**RE: Expert Review Services
Venue at Summer's Corner, Lennar Homes
Block 286 Lots 3, 5 & 6 Block 287 Lots 5 & 7
Little Egg Harbor Township, Ocean County, New Jersey**

At your request, this office has conducted a technical review of the land development application located in Little Egg Harbor Township, Ocean County, New Jersey. Our review was specifically focused on the project's compliance with applicable state and municipal stormwater management regulations.

Figure 1. Comparison of existing conditions plan (top) and recent aerial imagery (below).

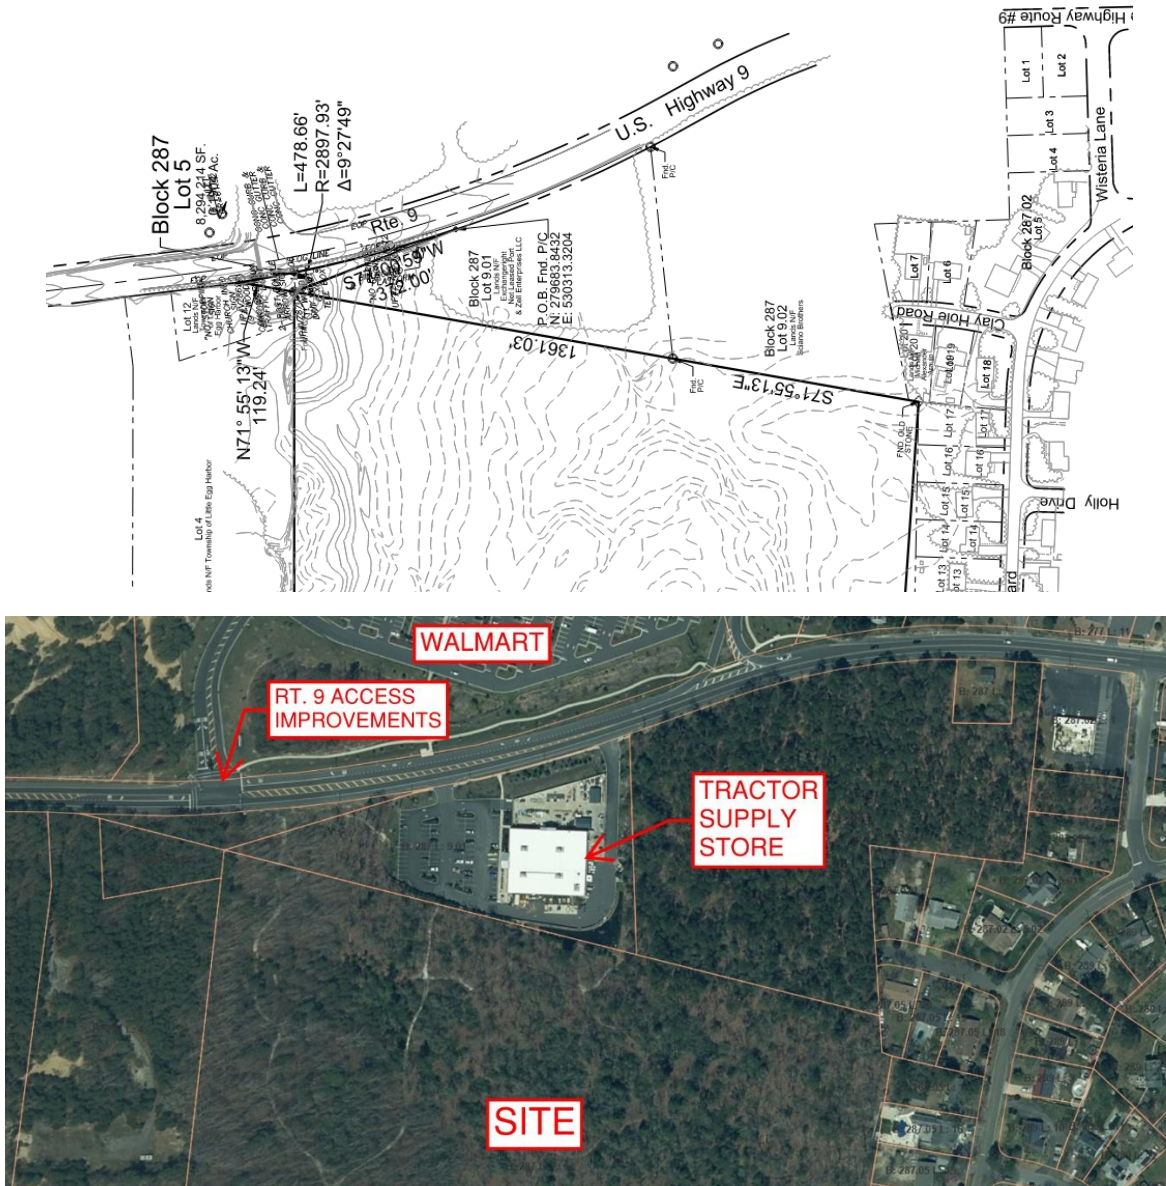
1. No current survey appears to have been provided with the application. However, the plans claim:

While these plans were not provided for review, the underlying survey features and topography are clearly not from 2024, as the plans do not show the existing Tractor Supply and Walmart

developments or the supporting access roads on N.J.S.H. Route 9, which were under construction as of 2015. The plans also lack several structures on adjacent lots including at least seven homes on Leitz Blvd. and even some features within the property in question. Some of the missing homes existed prior to 2006, making this information nearly twenty years out of date. The topography in these areas is also not consistent with the conditions in 2024. The entire submission is therefore based on outdated and inaccurate survey information that does not accurately reflect the current conditions near and within the site. The following figures show the applicant's existing conditions plan contrasted with an NJGIN 2020 aerial of approximately the same location with GIS parcel lines and annotations shown.

Figure 2. Plan showing proposed Road 'A' extension.

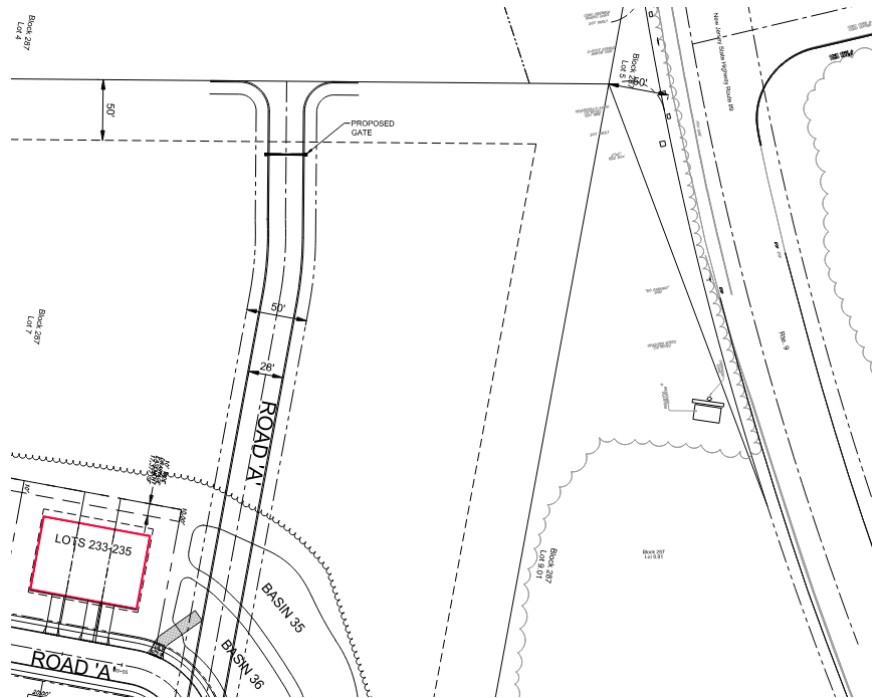
2. A plan for a proposed future road connection to N.J.S.H. Route 9 was provided with the application. This road appears to go nowhere, and a potential missing connector would require

easements from at least four lots. This proposed road intersects Basins 35 and 36. The design for the proposed “Road A” extension is nonsensical as can be seen in the figure below taken directly from the application plan set.

Figure 3. Drainage area mapping with additional annotations shown in blue.

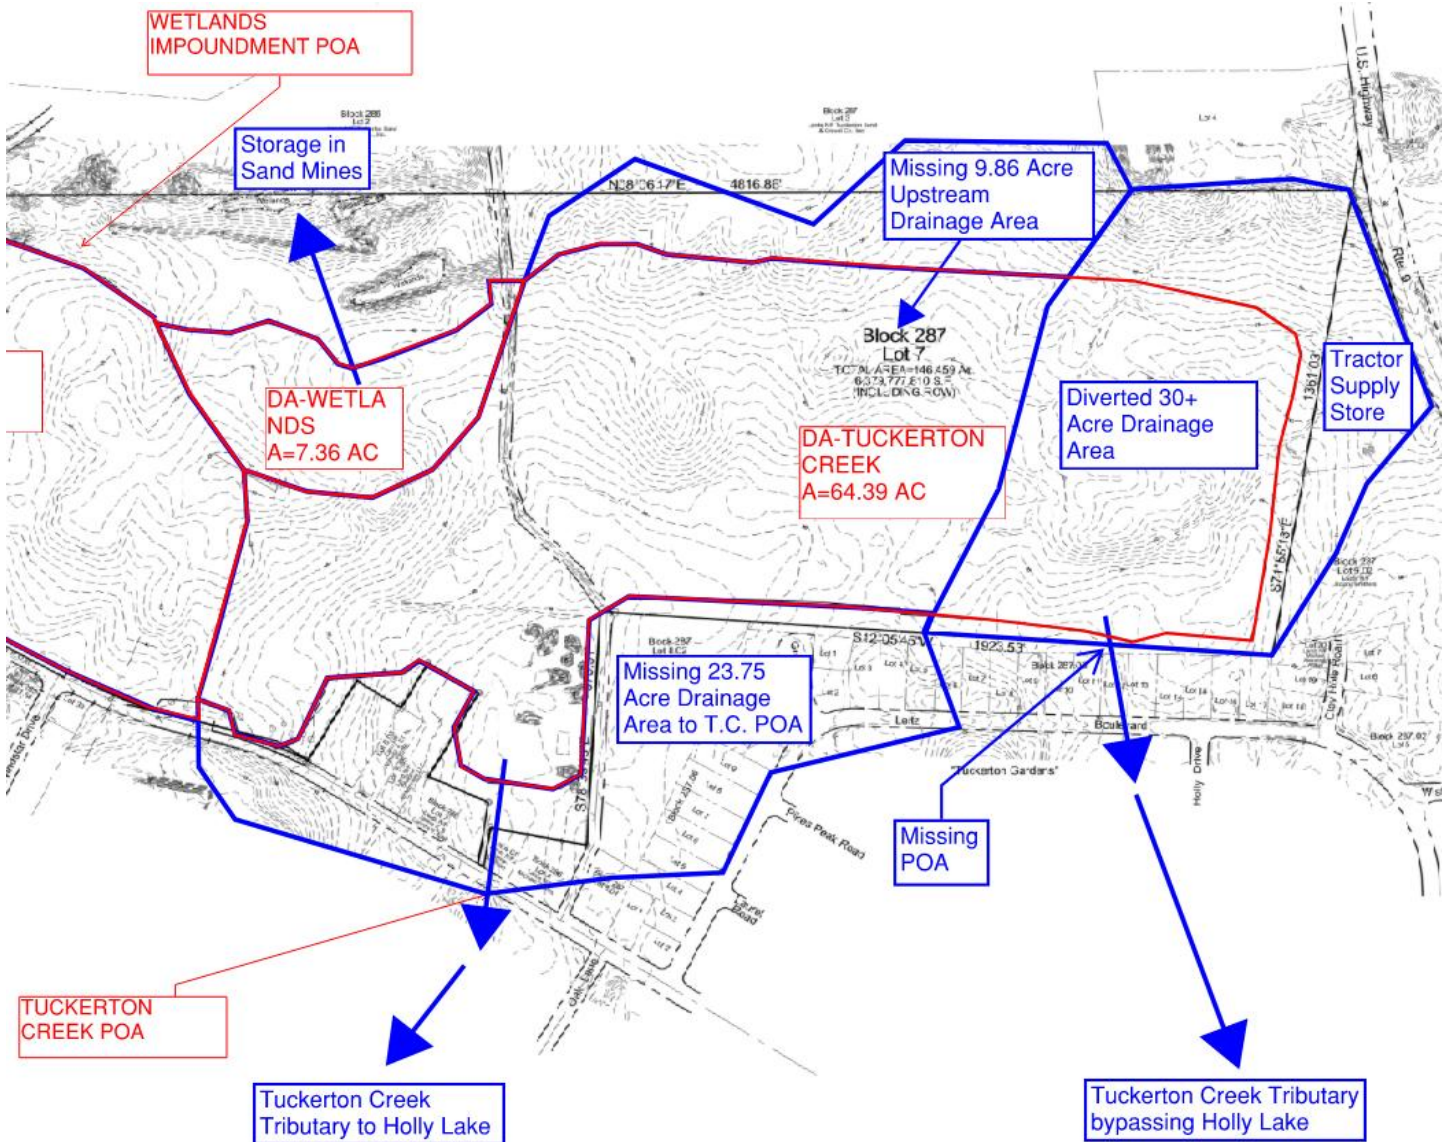
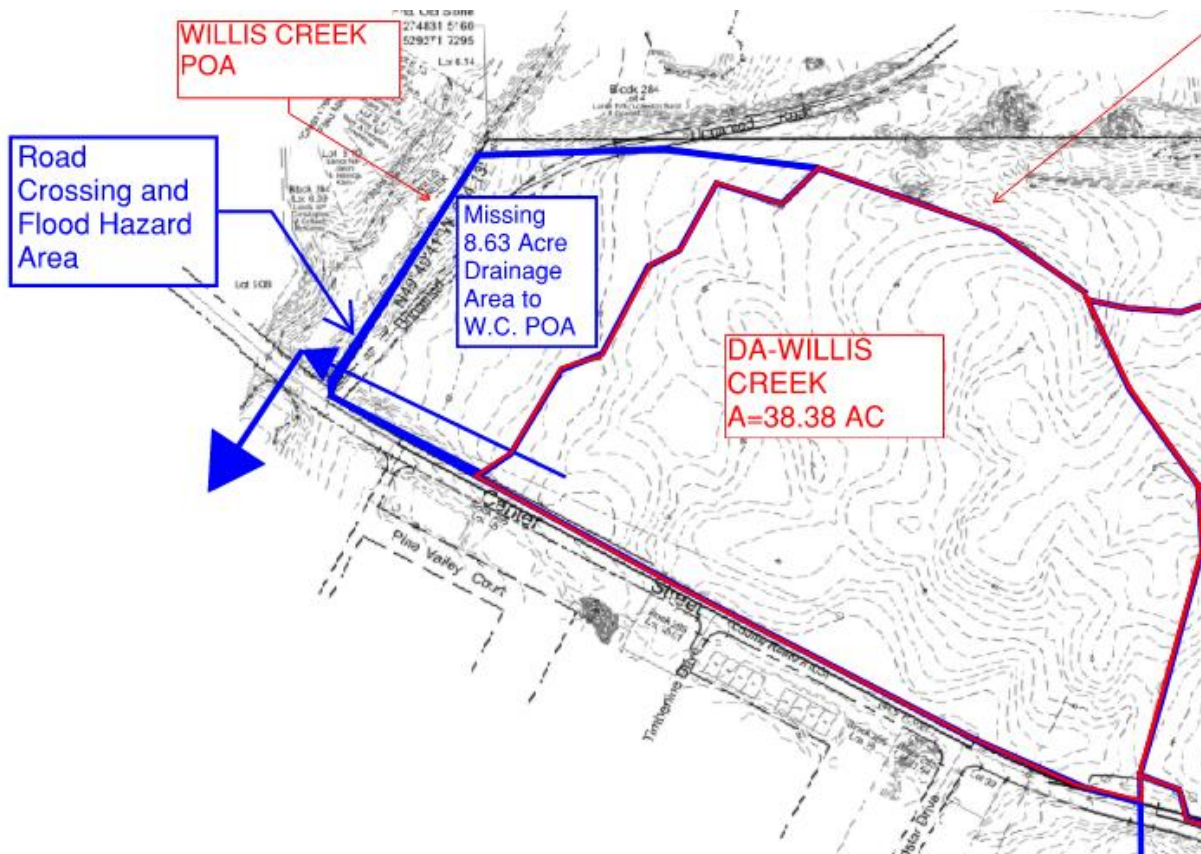
1. The analysis uses only two points of analysis (POA) for the watersheds of Tuckerton Creek and Willis Creek, where more POAs are needed to assess the existing condition accurately as described below based on the applicant's drainage area map. The applicant's approach

ignores many locations where stormwater runoff leaves the property. NJAC 7:8-5.6(c) states that "The stormwater runoff quantity standards shall be applied at the site's boundary to each abutting lot, roadway, watercourse, or receiving storm sewer system." The following figures show the applicant's drainage area map including the submitted drainage areas in their original red color with corrected drainage areas and points of analysis shown in blue. Please note this figure relies on the topography provided by the applicant.
